**SERVICE PROGRAM BULLETIN**

**APPLICABILITY:** 2015-16 MY Legacy and Outback

**NUMBERS:** WTH-68

**SUBJECT:** Engine No-Start Condition in Cold Climates

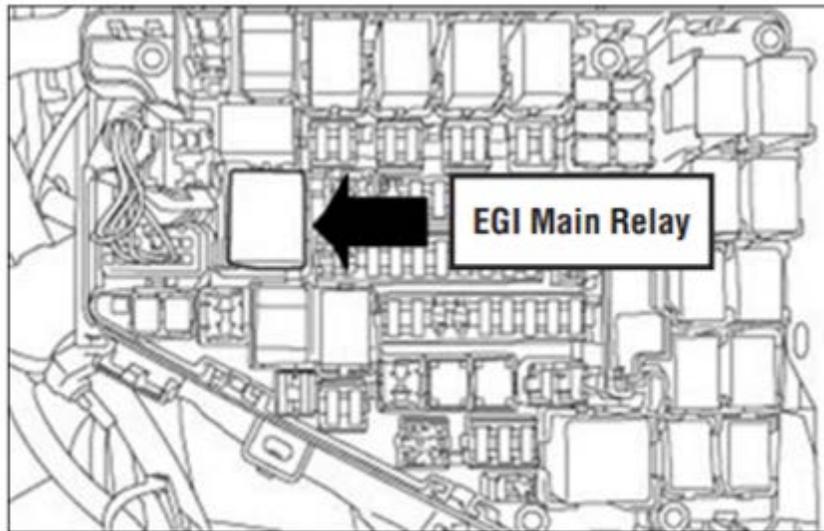
## PRODUCTION CHANGE INFORMATION:

The new EGI Main Relay was incorporated into production during mid-October, 2015 starting with the following VINs: Legacy: **G\*017247** and Outback: **G\*237505**.

The new EGI Main relay part number is **25232AA130**.
